SUBJECT: AOS RESPONSE TO NRC QUESTIONS (DATED 01-15-2019) TO
SUPPORT THE RESPONSE TO THE REQUEST FOR ADDITIONAL
INFORMATION ISSUED OCTOBER 9, 2018

USNRC Reference(s): Docket No. 71-9316
EPID-L-2018-LLA-0201

Alpha-Omega Services, Inc. (AOS) hereby submits the responses NRC questions (dated 01-15-2019) in support of the response to the requests for additional information (RAIs) for Certificate of Compliance No. 9316 issued on October 9, 2018. Each of the responses are provided below on both the matrix and in blue text following each additional question; and brown text are questions for future consideration. Applicable portions of Chapters 1, 2, 3, 5, 7, and 8 of the Safety Analysis Report are resubmitted to incorporate clarifications as indicated in the RAI responses.

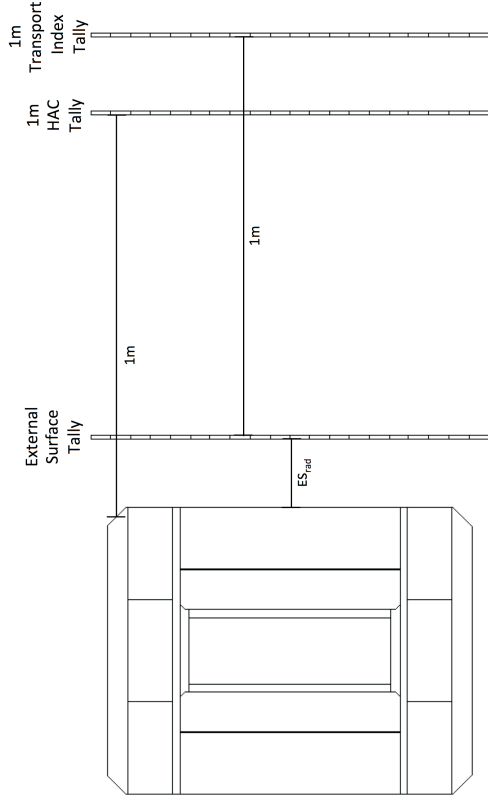
L.3. Various places seem to be missing reference to Table 1-2b (e.g., Appendix 5.5.1, the 4th paragraph)

Response: Corrected (Page 5.28) Appendix 5.5.1 4th Para., 4th line to add reference to Table 1-2b
